**PSE&G** Public Service  
Electric and Gas  
Company

August 20, 1984

HOPE CREEK GENERATING STATION  
DOCKET NO. 50-354  
DRAFT SAFETY EVALUATION REPORT  
OPEN ITEM STATUS

Attachment 1 is a current list which provides a status of the open items identified in Section 1.7 of the Draft Safety Evaluation Report (SER). Items identified as "complete" are those for which PSE&G has provided responses and no confirmation of status has been received from the staff. We will consider these items closed unless notified otherwise. In order to permit timely resolution of items identified as "complete" which may not be resolved to the staff's satisfaction, please provide a specific description of the issue which remains to be resolved.

FIGURE ~~1008~~ 210.21-5C  
 RESPONSE SPECTRA COMPARISON,  
 INTAKE STRUCTURE AT ELEV. 114' - 0",  
 VERTICAL, SSE, 2% DAMPING

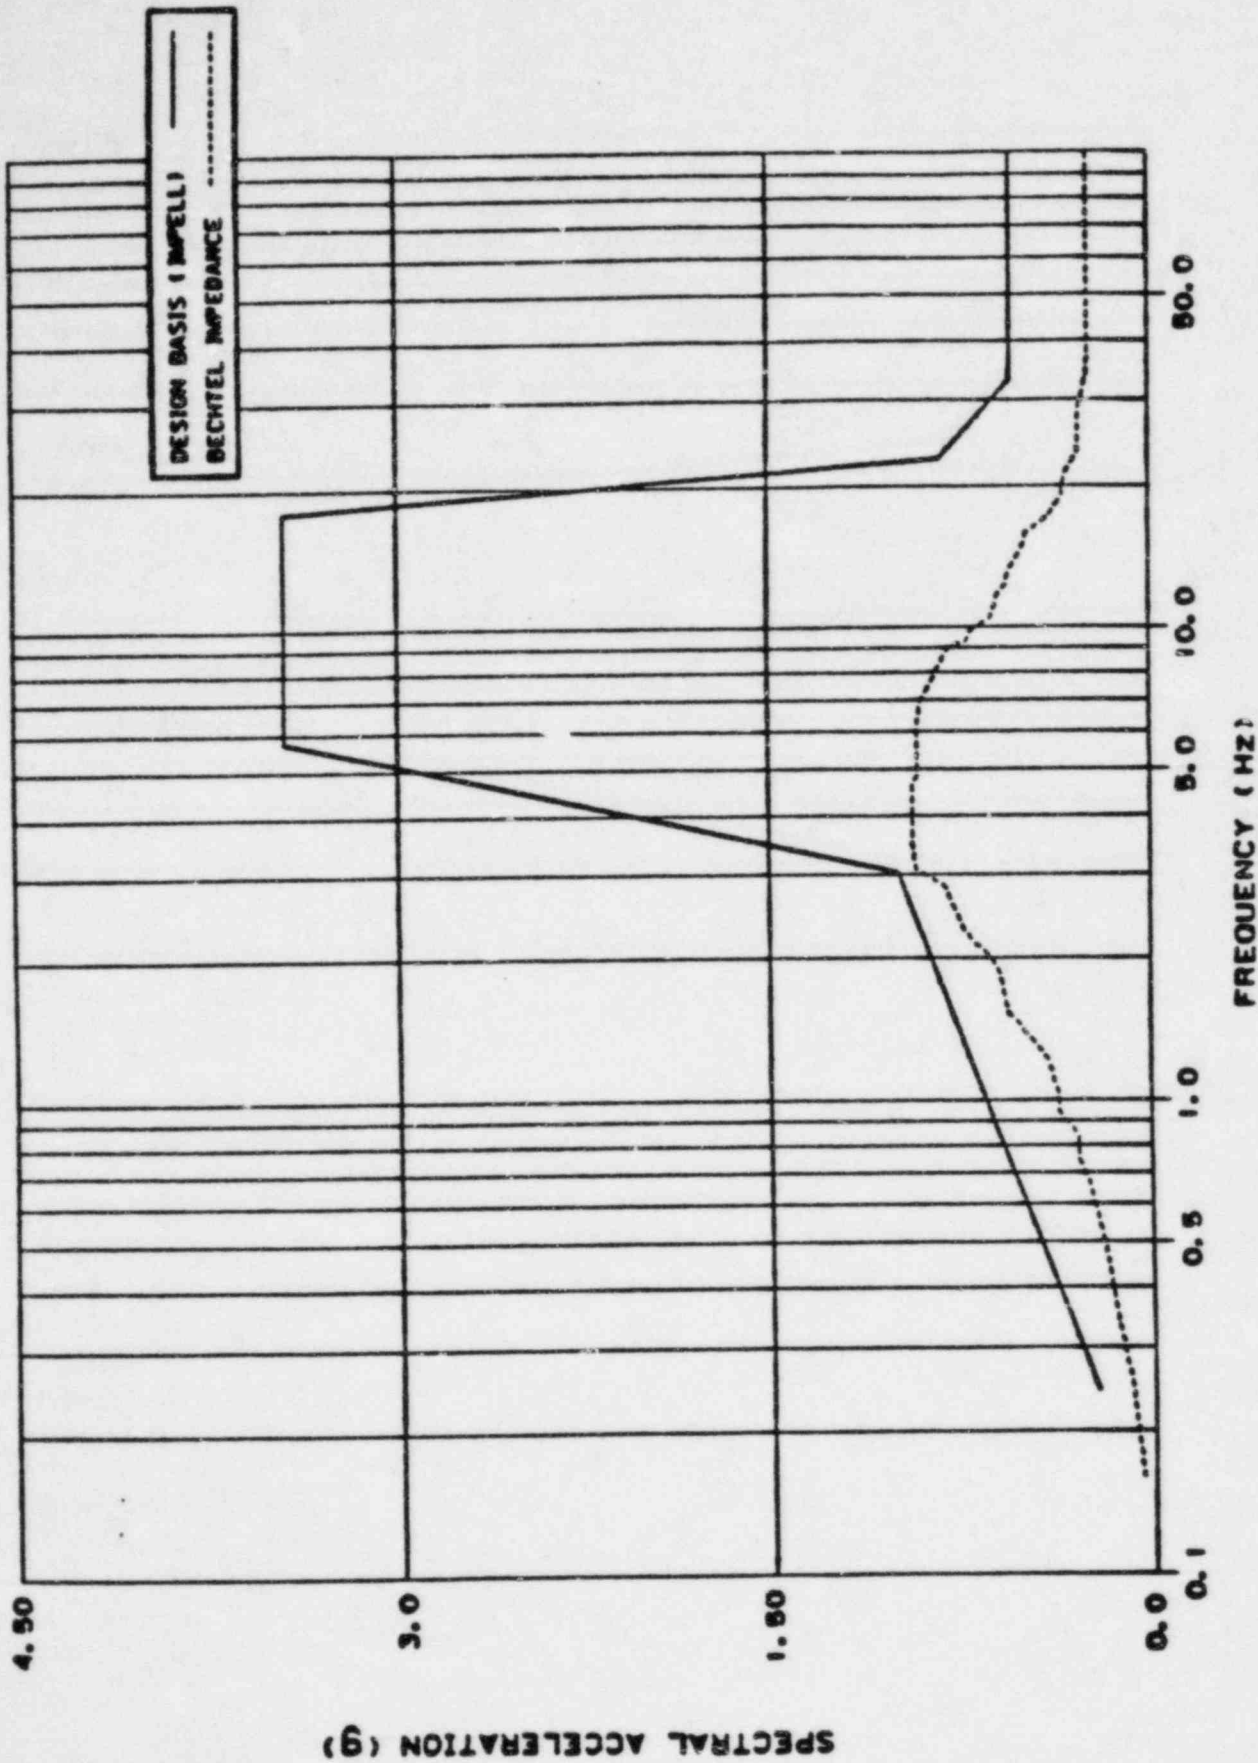
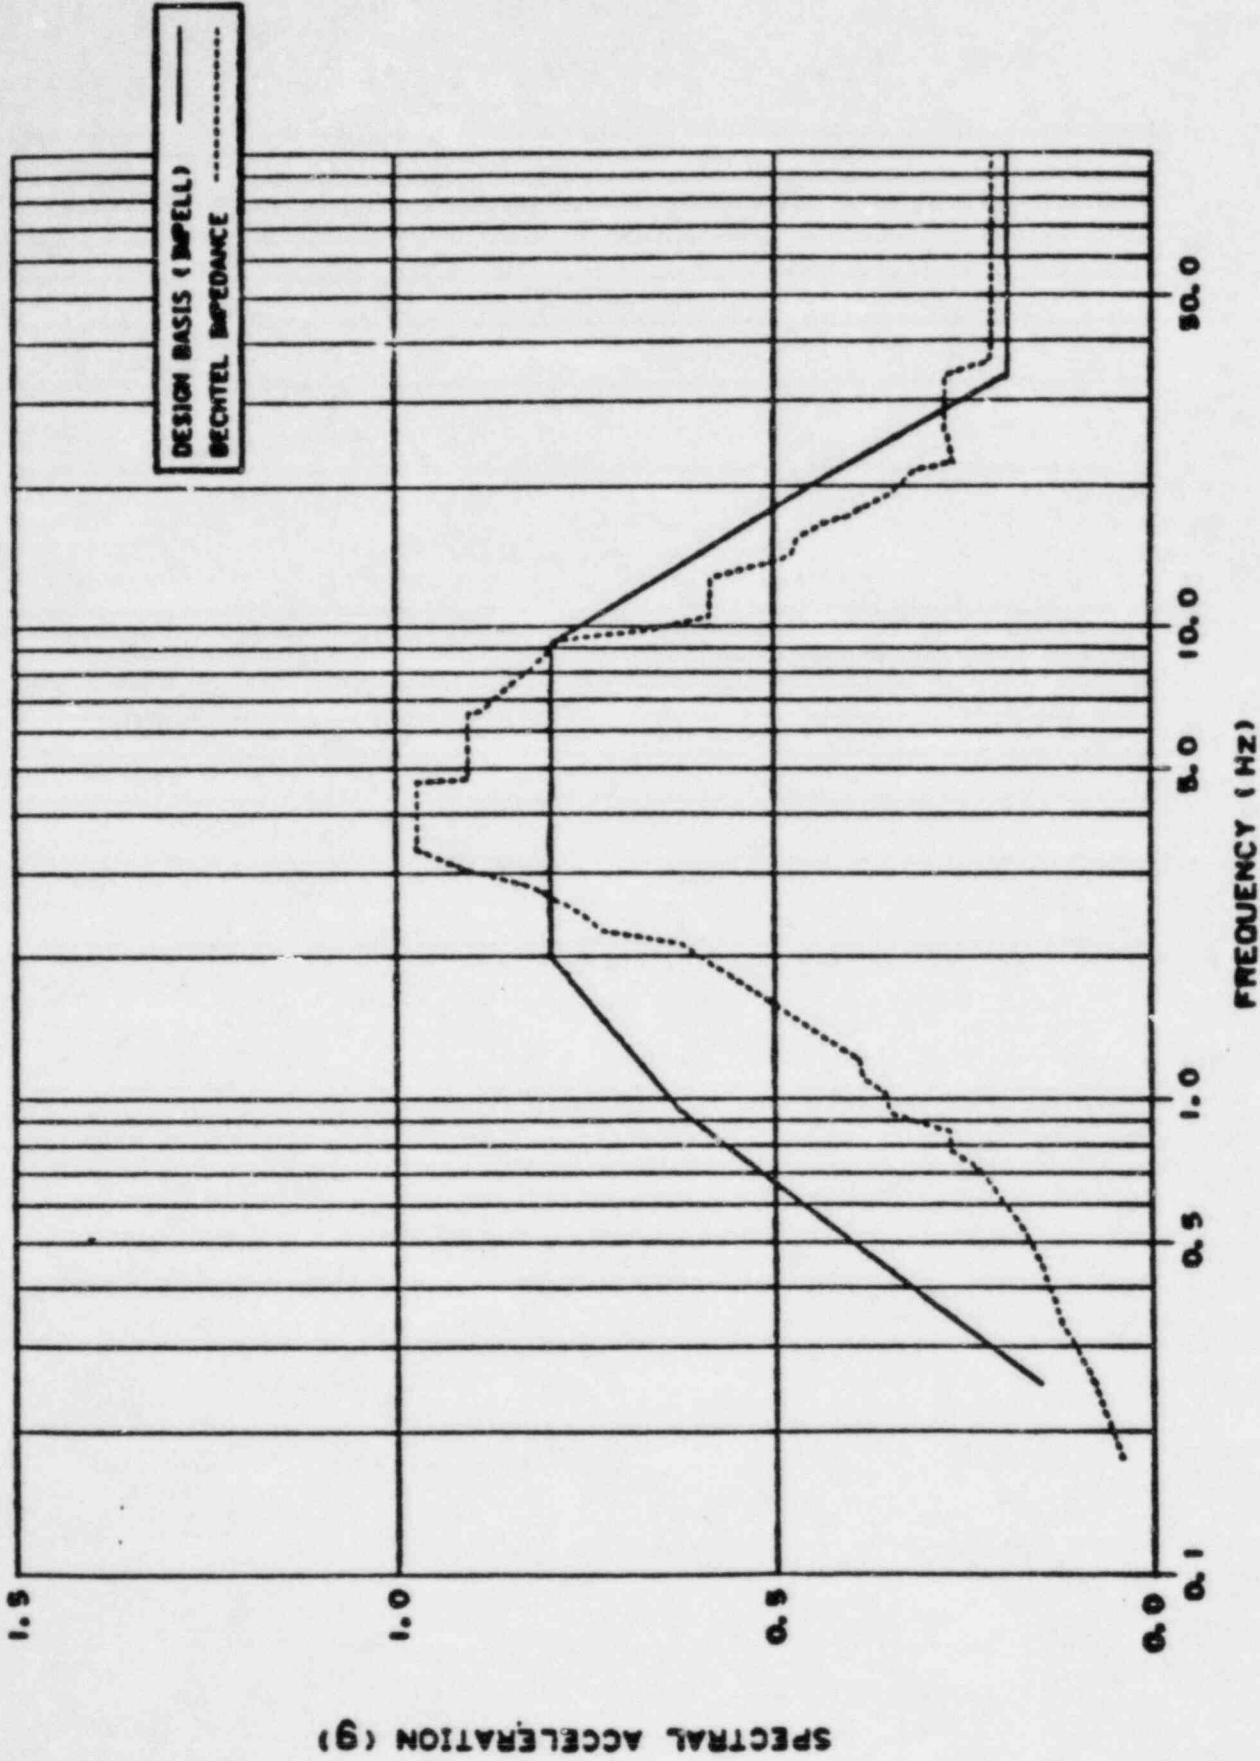
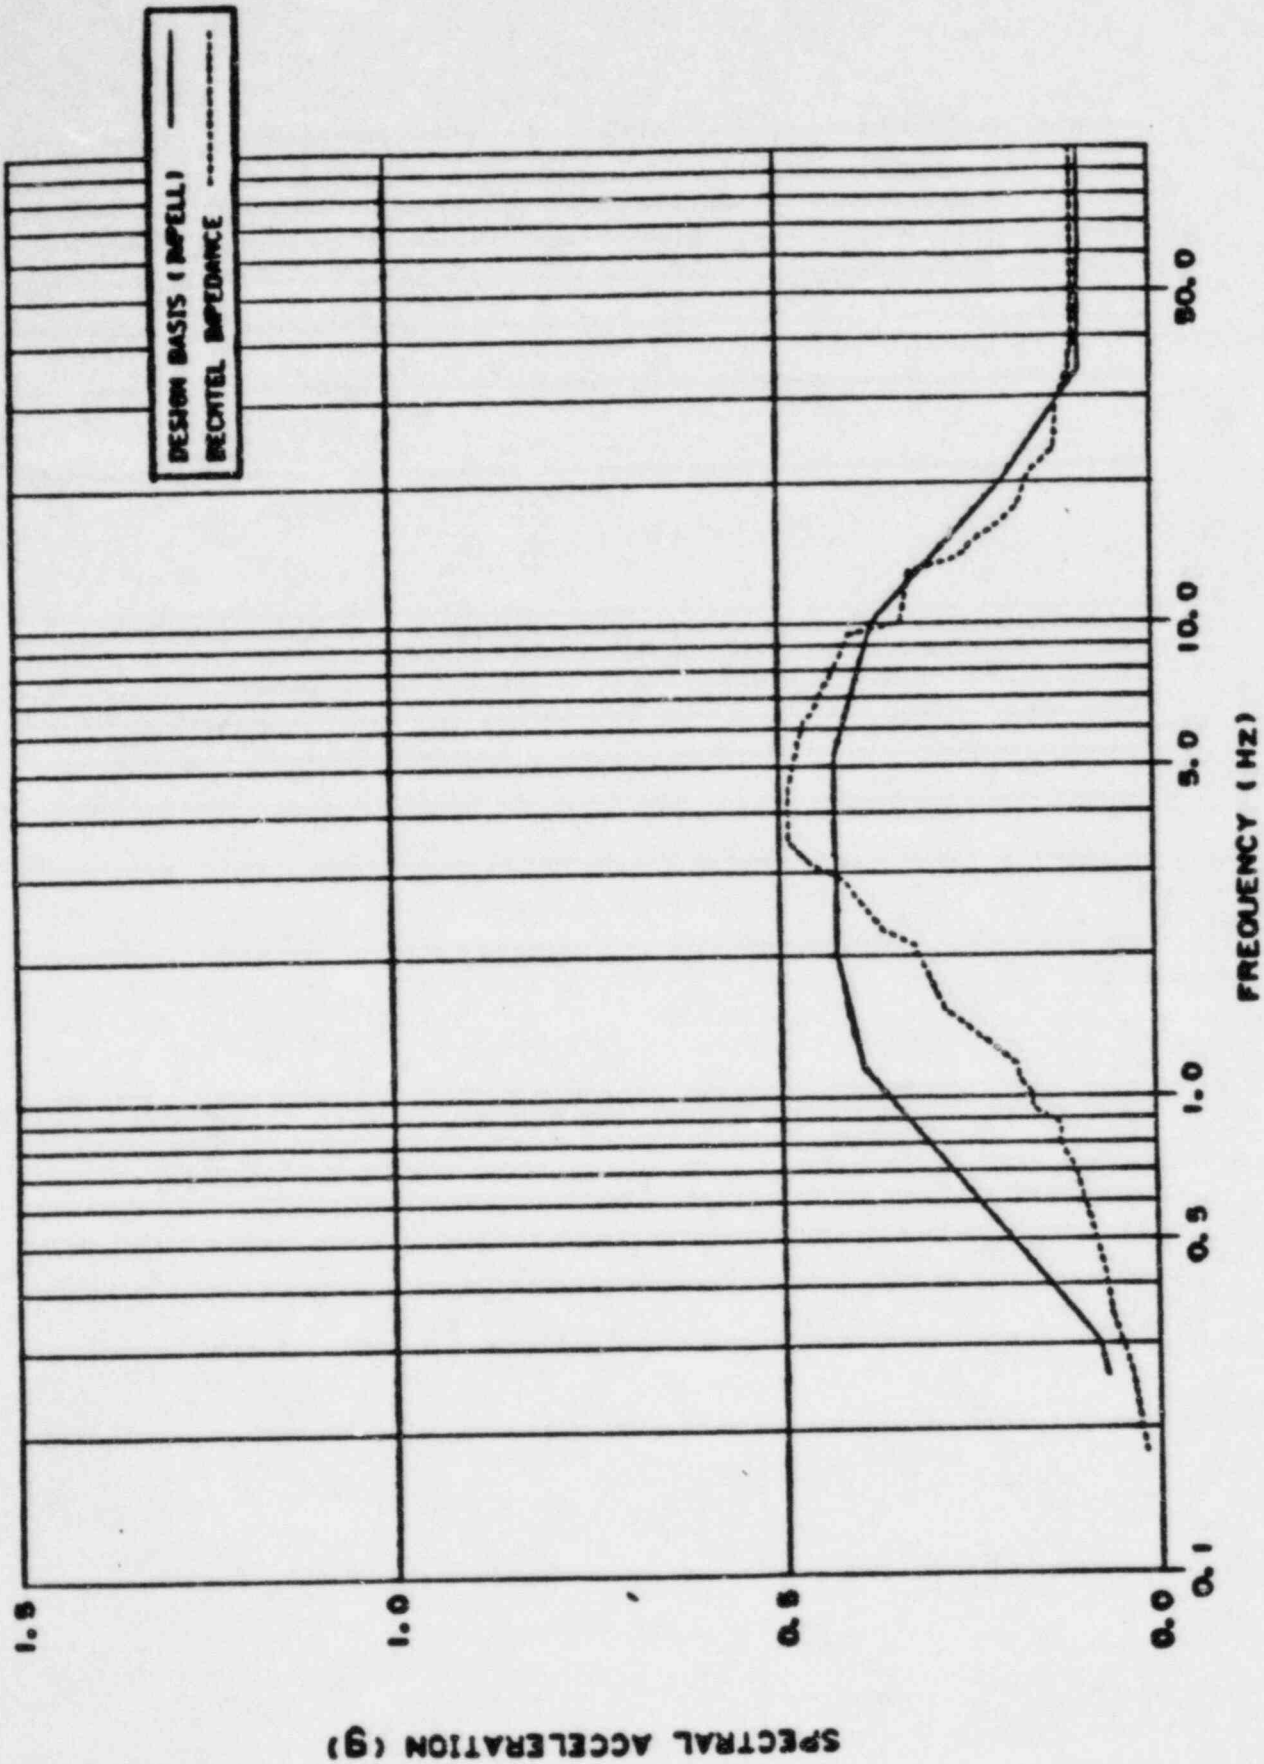
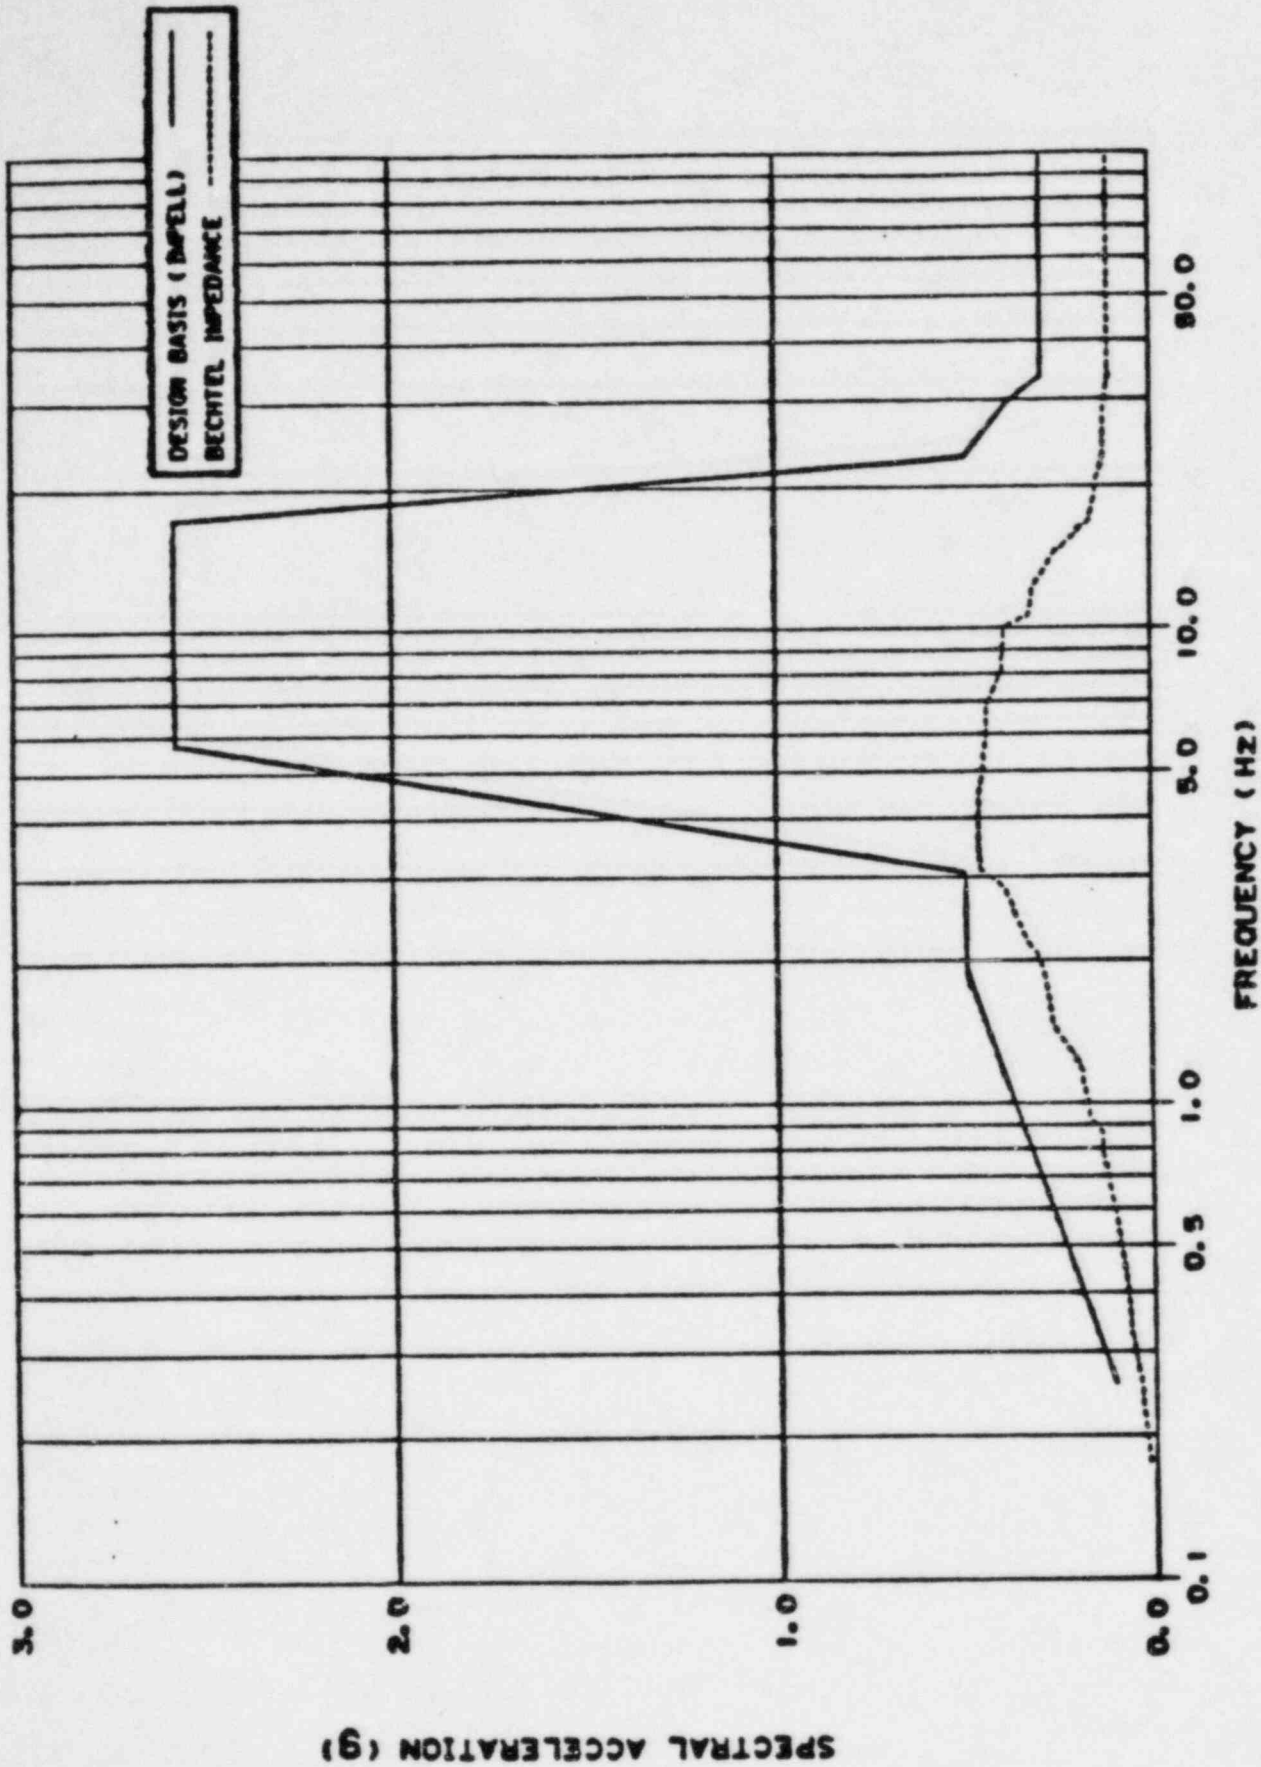
Figures 220.21-1 through 220.21-54 show a comparison of the 2 percent damping response spectra obtained from the design basis finite element and the impedance analyses for the reactor building, auxiliary building and the service water intake structure (SWIS).

¶ For the reactor and auxiliary buildings, the peak spectral accelerations obtained from the impedance analysis are generally lower than those obtained from the design basis analysis. However, the impedance analysis response spectra are not completely enveloped by those obtained from the design basis analysis, especially in the frequency range from 1.0 to 3.5 Hz. Also, there are some local exceedances in the higher frequency range, as shown in Figures 220.21-1 through 220.21-36. ¶ For the SWIS (Figures 220.21-37 through 220.21-54), the impedance analysis response spectra are generally enveloped by those obtained from the design basis analysis at elevation 114.0 feet. For other elevations, the impedance analysis spectral accelerations exceed the design basis spectral accelerations in some frequency ranges. These ranges vary approximately between 1.5 and 10.0 Hz.

In all cases, the items reviewed during these sampling studies can accommodate the loads resulting from the impedance analysis. Therefore, the impedance analysis results have no impact on the plant design.
